Version 4

A/C Does Not Blow Cold Air and Condenser Leaks at Receiver Dryer Cap

Supersedes 18-080, dated October 4, 2018, to revise the information highlighted in **yellow**

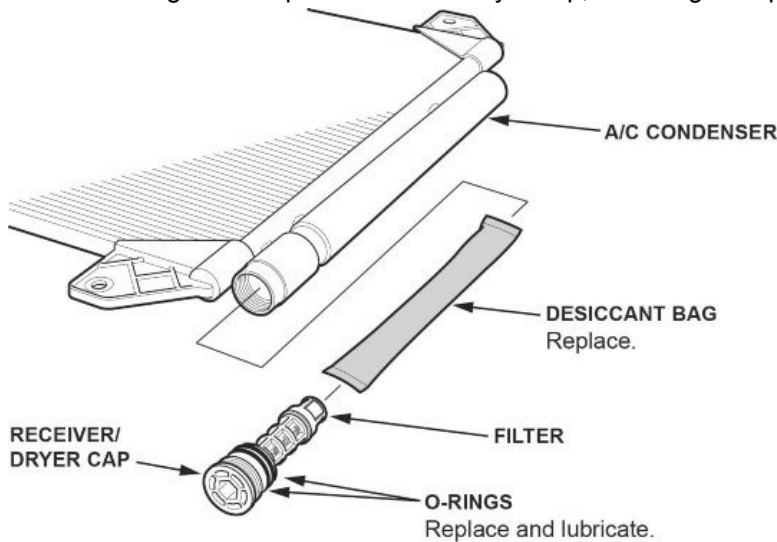
Check if the A/C is blowing cold air and there is staining around the receiver dryer cap on the condenser.

- If the A/C is not blowing cold air and there is staining around the receiver dryer cap on the condenser, go to REPAIR PROCEDURE.
- If the A/C is not blowing cold air and there is no staining around the receiver dryer cap, continue with normal system troubleshooting.
